DESIGN REVIEW | 550 BROADWAY

DPD Project No.: 3012198 November 21, 2011

BOARD RECOMMENDATIONS 550 BROADWAY DPD #3012198 | AMAA #110475

HOT BUTTONS:

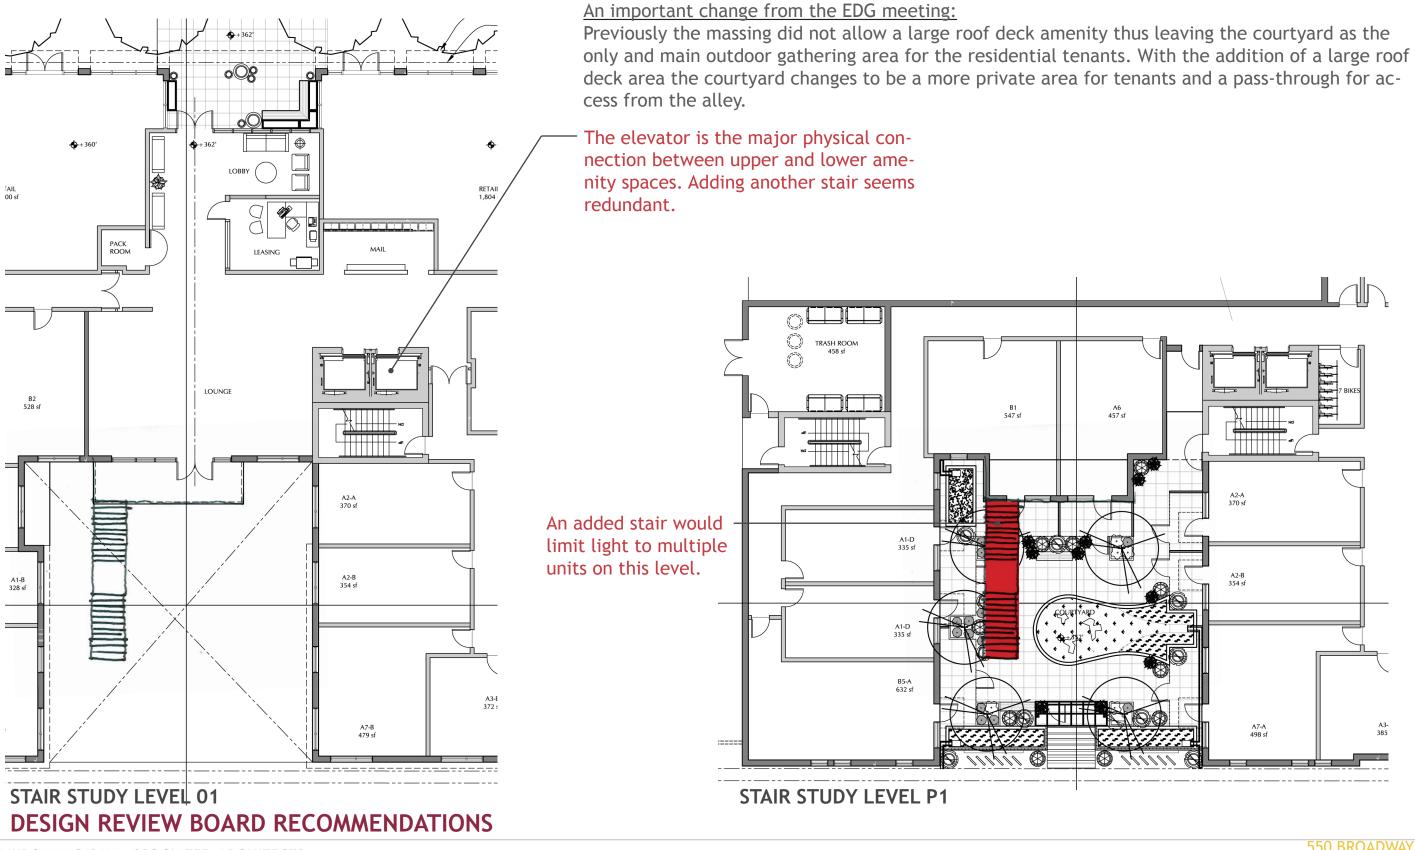
"Based on considered discussion, the Board agreed with the concept of an east facing courtyard. It will need to be part of a larger organizing idea or parti expressing a significant sequence of interior and exterior spaces that connect Broadway and the alley with one another. The spaces should flow physically and visually into one another with attractive stairs and/or terraces that aid and enhance the transition."

DEPARTURE REQUEST

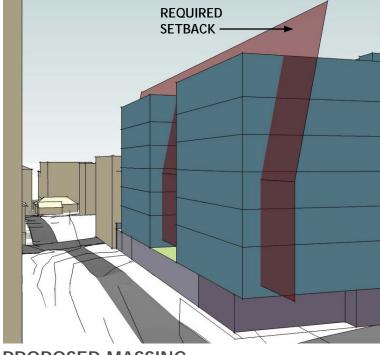
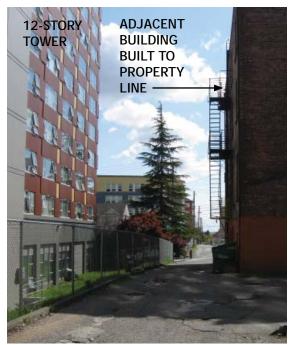
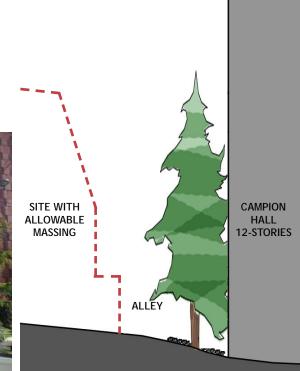
For a structure containing a residential use, a setback is required along any rear lot line that...is across an alley from a lot in a residential zone as follows: 15' for portions of structure 13' in height to a max of 40'. And then, additional setback at the rate of 2' for every 10' of height exceeding 40'. One half of the width of the unimproved alley may be counted as part of the required setback.

Allow the new building to encroach on the setback. The spirit of the zoning ordinance is for the protection of sun exposure on residential zones. The tower adjacent to the site is not the formal type the zoning is intended to protect. The adjacent building casts the entire site in shadow, where the new building would cast small shadows on only the lowest floors of Campion Hall.

• Intention os this setback is to provide mitigation next to a lower residential zone; adjacent building is 105' in height

• Proposed design is 1 story lower than permitted by zoning, casting a shadow comparable to taller structure with required setback

• Existing building to south is built against property line with no setbacks

• Building to the east is a 12-story student residence hall, but zoning intention was for preserving lower built residential lots

• Building is already pushed east 7' due to power line clearance requirement, and this helps to maintain developable area of property

• The effect on perceived height and shadows is minimal
